**FINAL
DEFENSE DISTRIBUTION REGION WEST
TRACY, CALIFORNIA**

**OPERABLE UNIT 1
EXPLANATION OF SIGNIFICANT DIFFERENCE**

**for the Change from
Groundwater Extraction and ReInjection
of Treated Groundwater to
Groundwater Extraction, ReInjection of Treated Groundwater
and Dispersion**

January 1996

DEFENSE DISTRIBUTION REGION WEST - TRACY
 IMPACT OF PREFERRED WELL FIELD SCENARIO
 ON COMBINED TCE / PCE PLUME
 UPPER HORIZON
 AFTER 8 YEARS

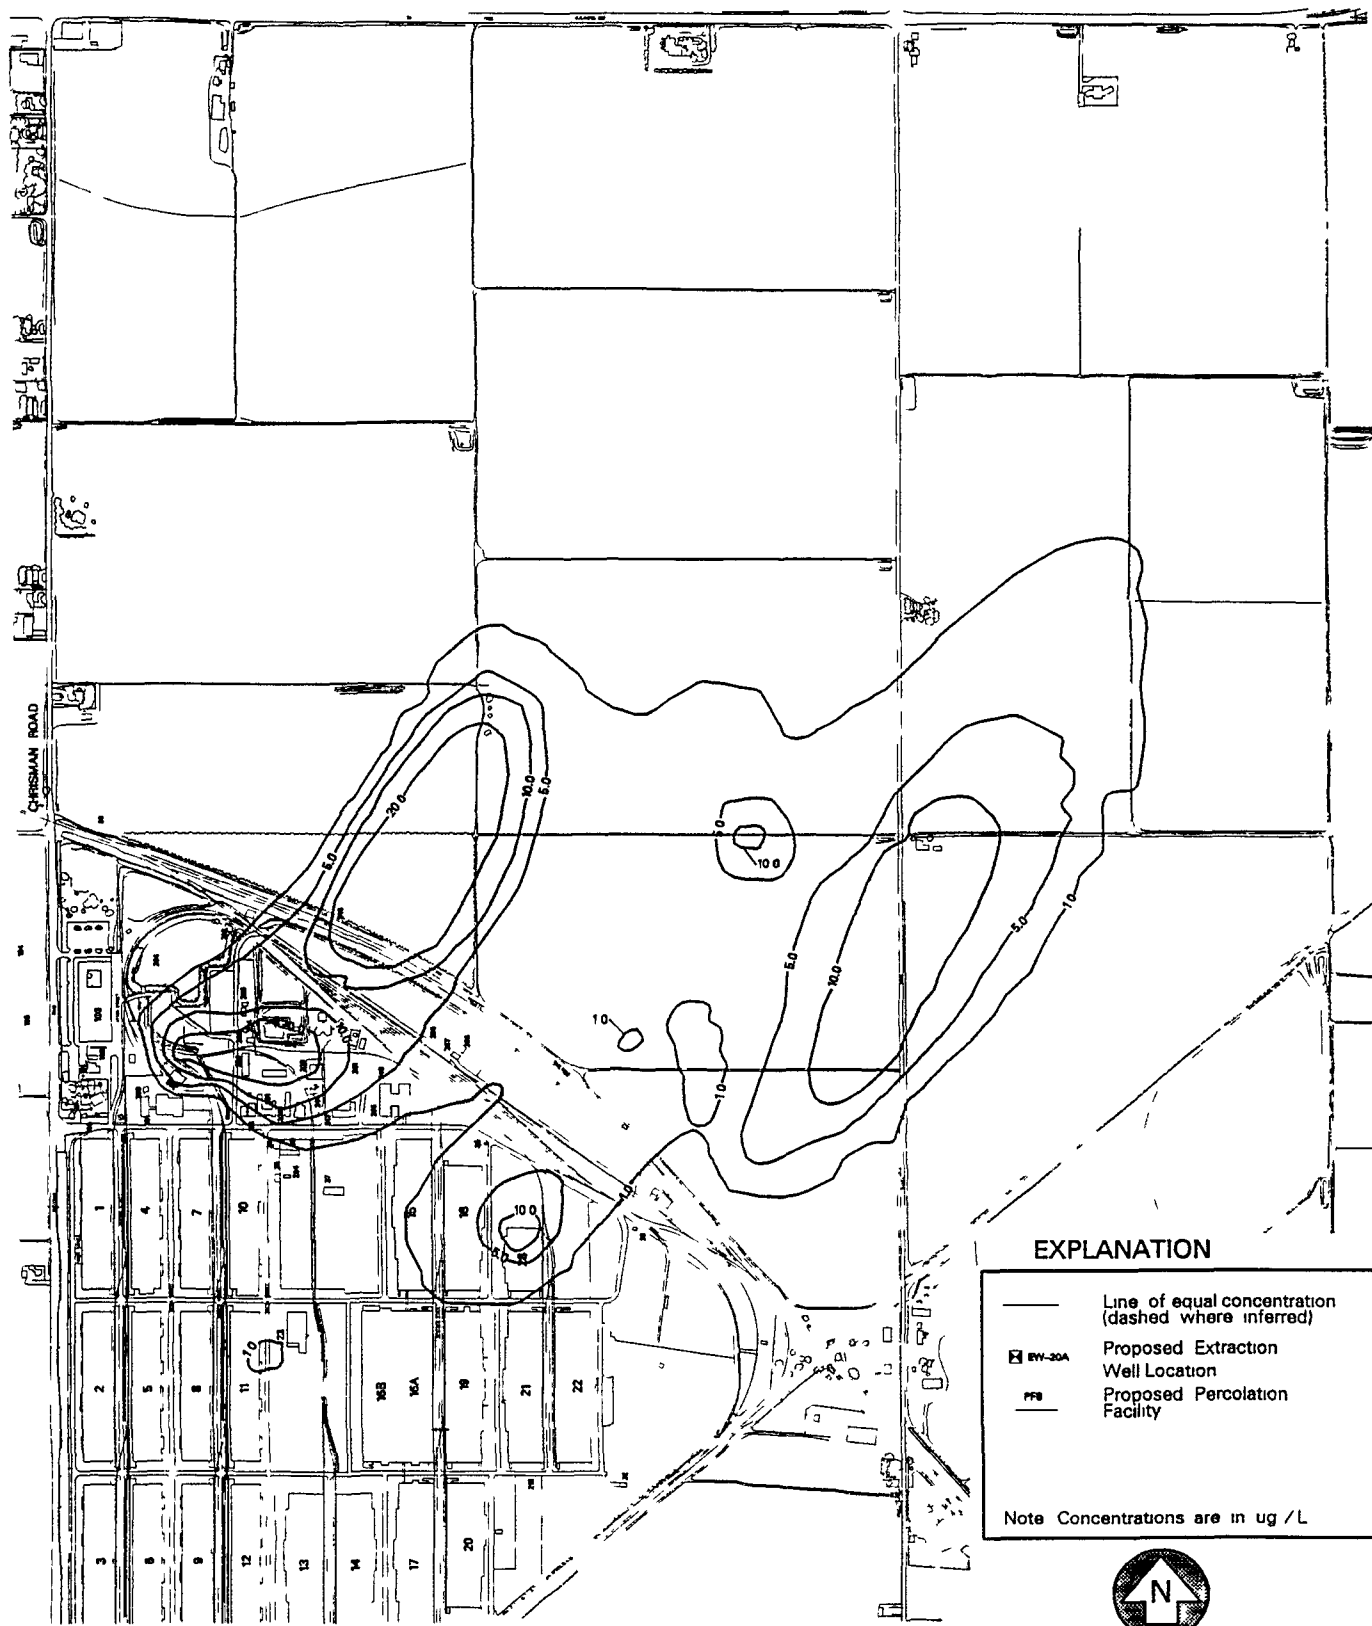
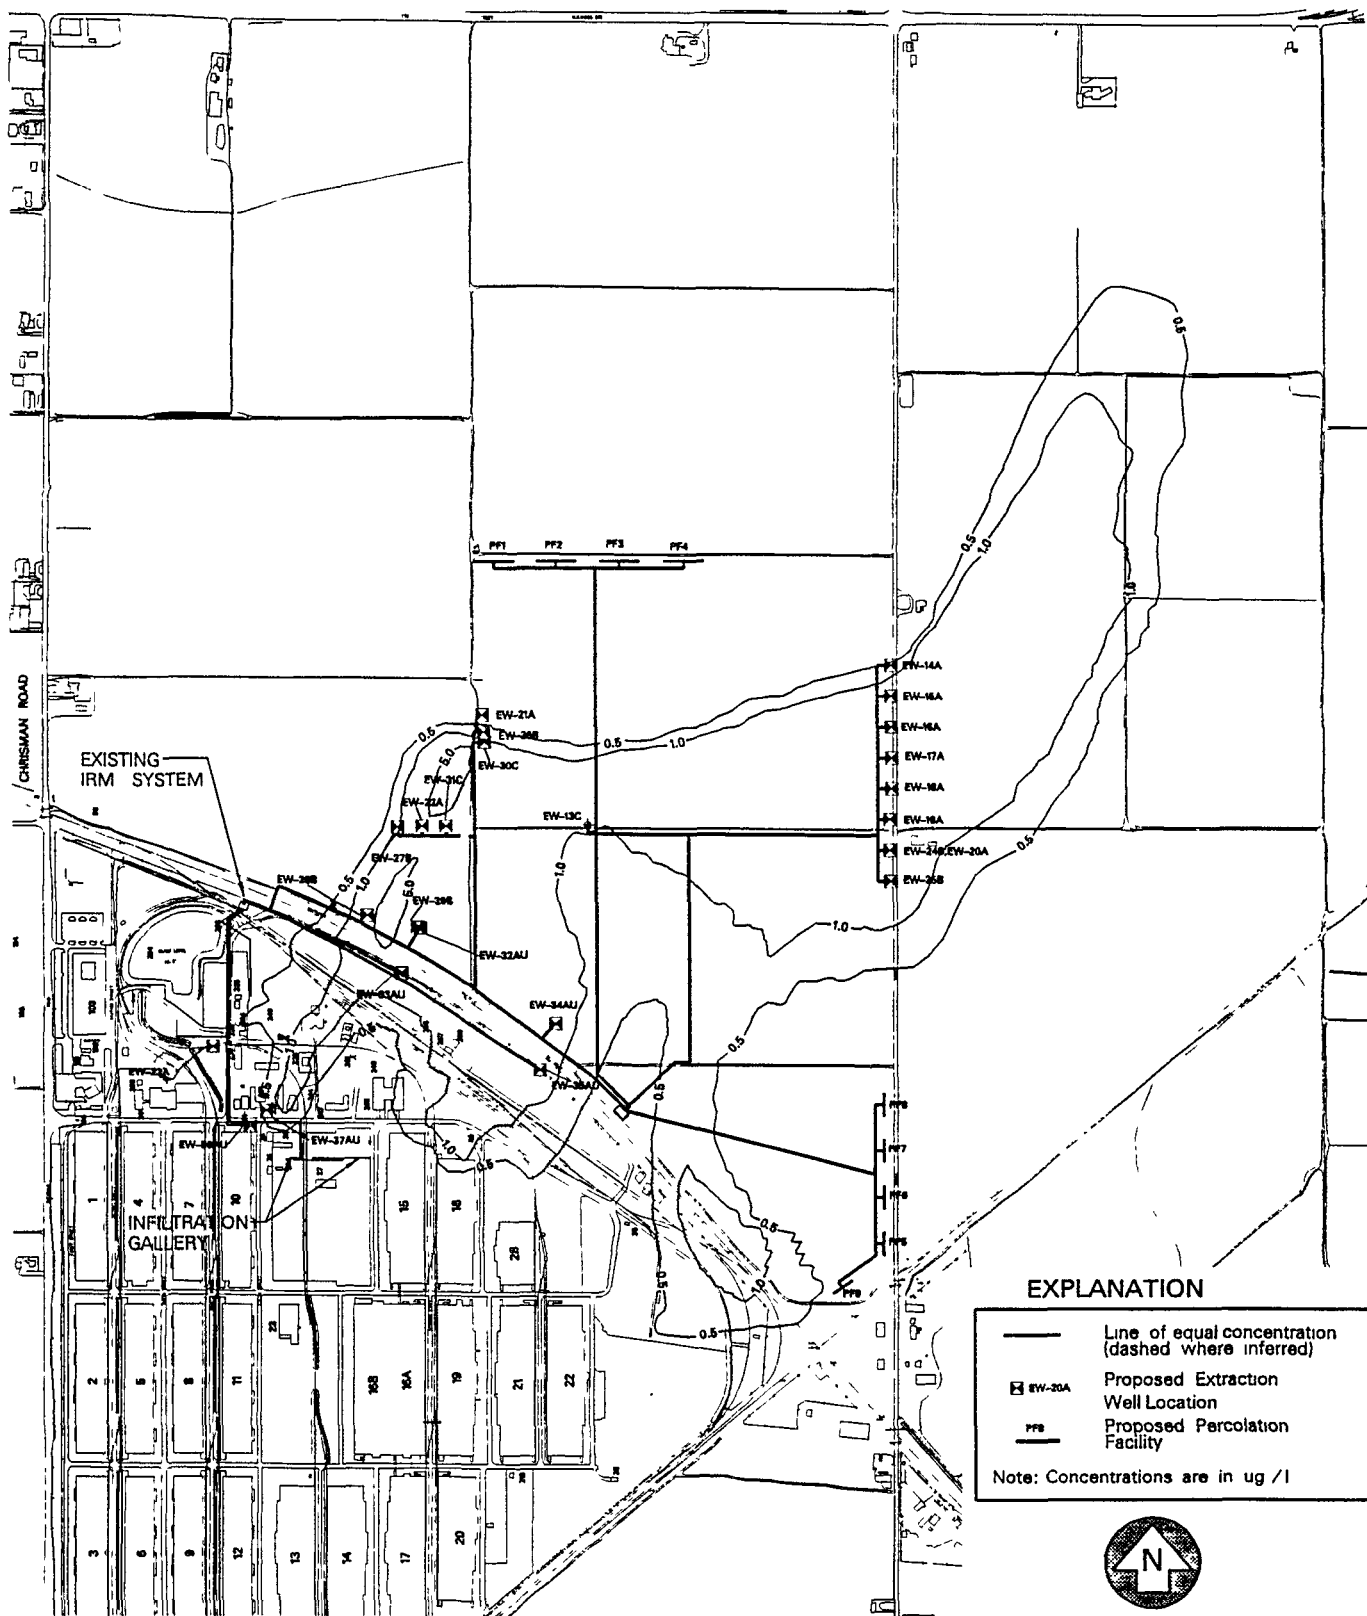
In summary, the change from hydraulic capture and groundwater extraction to a combination of hydraulic capture, groundwater extraction, and dispersion only affects the easternmost and lowest concentration portion of the PCE/TCE plume. Groundwater modeling results indicate that dispersion of the plume east of Banta Road will result in achievement of MCLs within a period of ten years. Figures 2 through 7 illustrate the predicted combined PCE/TCE plume from initial conditions through ten years of operation.
